NRC/DOE PRE-LICENSING INTERACTIONS IN GEOLOGY PROPOSED PALO DURO HIGH-LEVEL WASTE SITE

JOHN S. TRAPP
GEOLOGY/GEOFYSICS SECTION
DIVISION OF WASTE MANAGEMENT
19 MARCH 1986

STRUCTURE CONTOUR MAPS ON PRECAMBRIAN BASEMENT

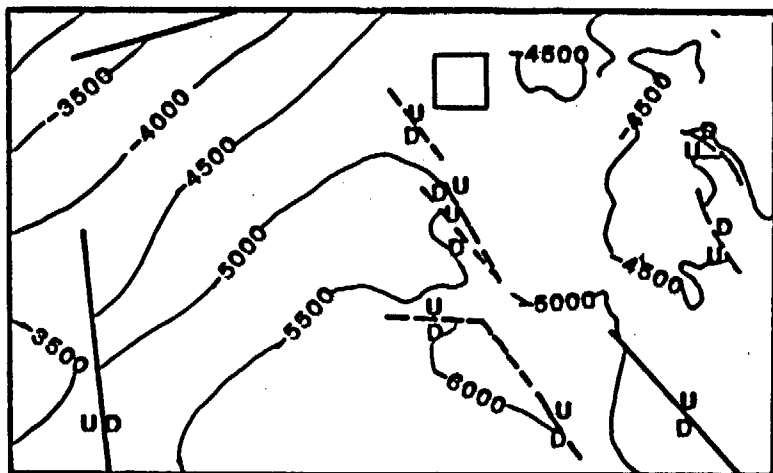
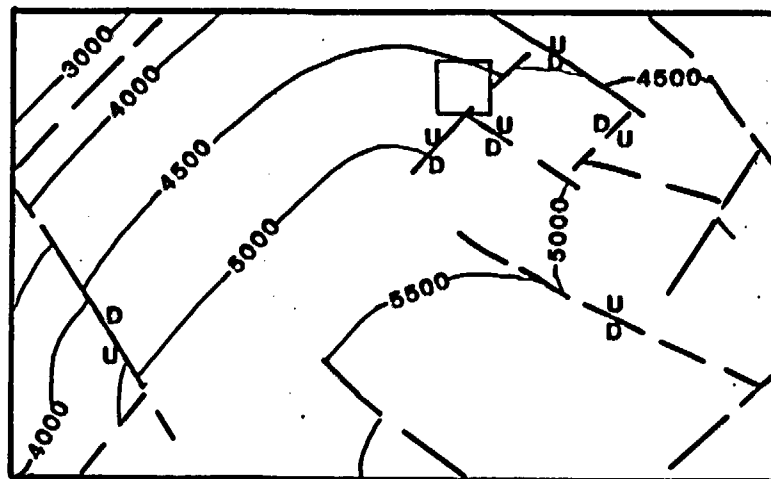
WHAT IS THE NATURE AND DISTRIBUTION OF
STRUCTURAL DISCONTINUITIES?

TWO DRAFT REPORTS AVAILABLE FOR REVIEW
WIDE RANGE IN INTERPRETATION OF DATA
REMOTE SENSING DATA NOT FULLY UTILIZED
VERY WIDE RANGE OF STRUCTURAL INTERPRETATIONS

RELEASE OF PENNZOIL PROPRIETARY SEISMIC DATA
